DATE: 09.25.2019
TO: ProTrak
FROM: Mitesh Baxi
Traffic Engineering

■ **MCDONALD'S GORDON ROAD [TRC Plan Review]**

↻ Initial Review Note ↻

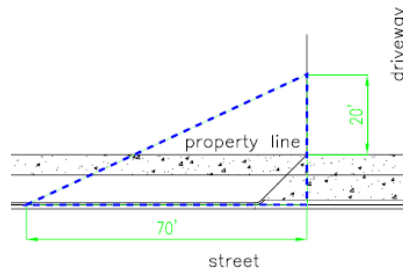
- Revise relevant sheets to accurately illustrate the existing conditions on and surrounding this parcel. Show all adjacent traffic signs, lane configurations, traffic control devices and pavement markings for the full intersection of Market St and Gordon Rd ROW on the site inventory plan. Please refer to the Technical Standards and Specifications Manual (link is below) Ch. VII C.1.a.2. for specific information and distance requirements. Contact Traffic Engineering at 341-7888 if you need assistance locating these elements.
<https://www.wilmingtonnc.gov/home/showdocument?id=1910>
